SERVICE BULLETIN

ENGINE INDICATING – ENGINE VIBRATION MONITOR (EVM) HARNESS – MODIFICATION
OF CLIPPING POINTS CP0877, CP0879 AND CP1210

V2500 Series 77-0014

V2500-ENG-77-0014

REROUTING OF THE EVM HARNESS - V2500-A5 ONLY
FIGURE 2, SHEET 4

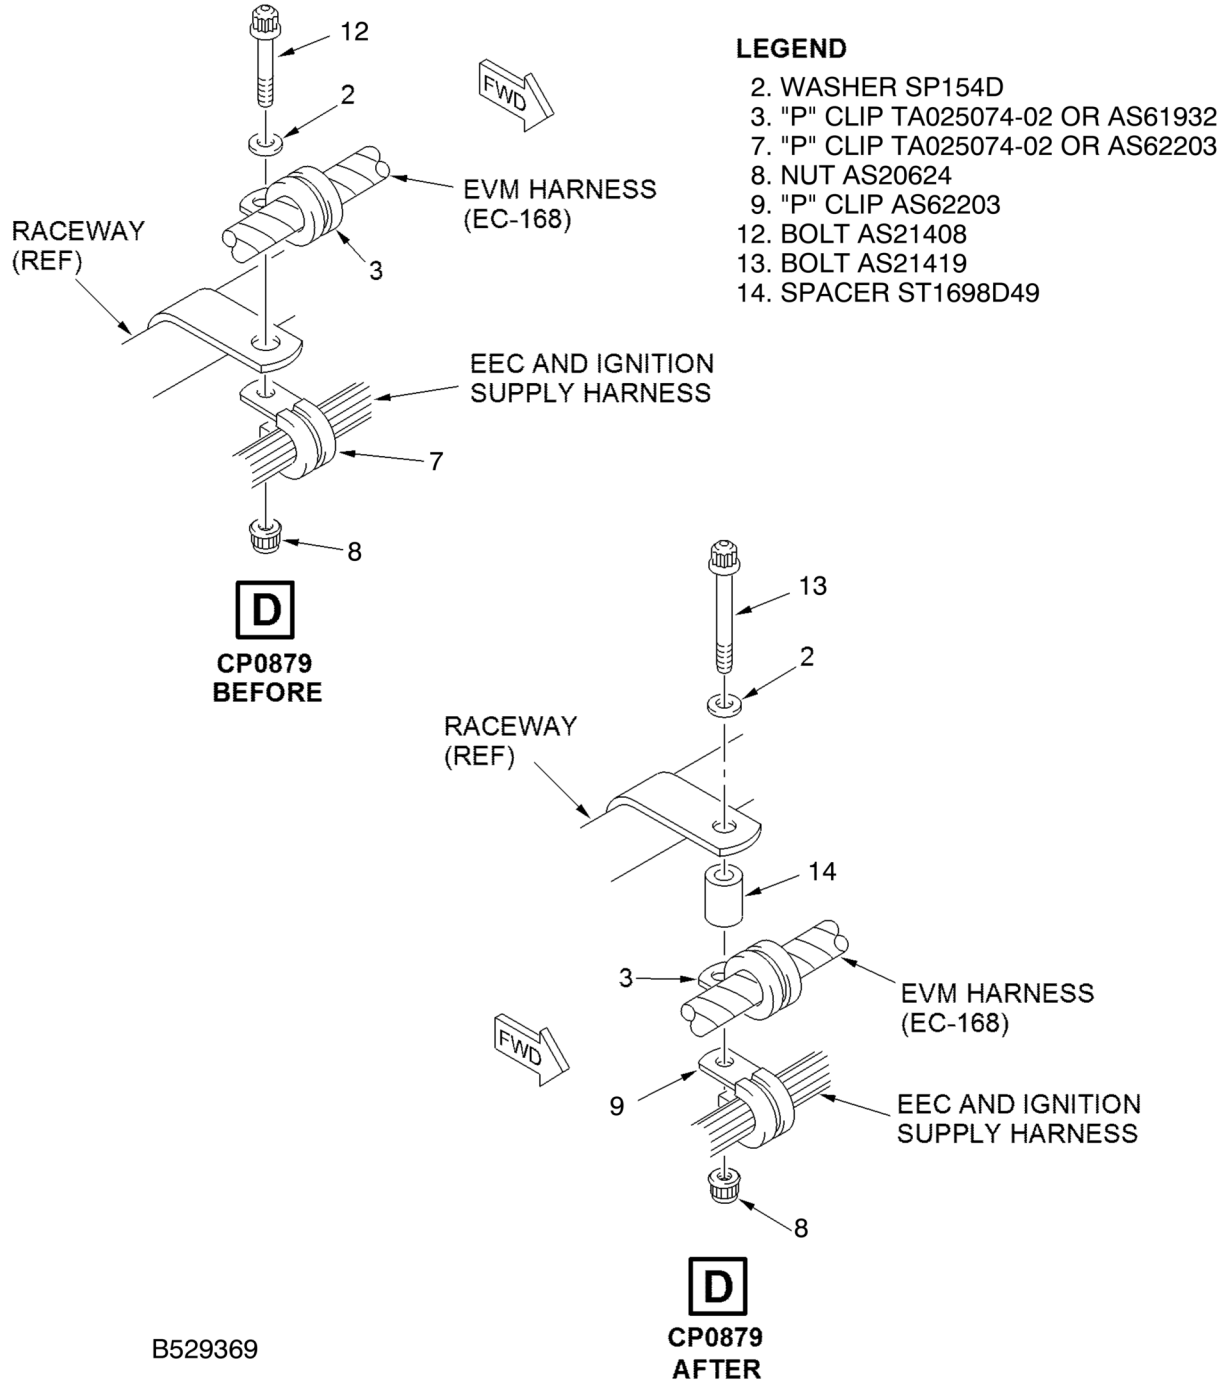
- I. At clipping point CP0879, attach the EEC and Ignition Supply Harness and the EVM Harness to the raceway with the 'P' Clip, PN TA025074-02, or PN AS61932 (3), the 'P' Clip, PN AS62203 (9), the Bolt, PN AS21419 (13), the Washer, PN SP154D (2), the Spacer, PN ST1698D49 (14) and the Nut, PN AS20624 (8). Refer to Figure 2, Sheet 4, View D (After).
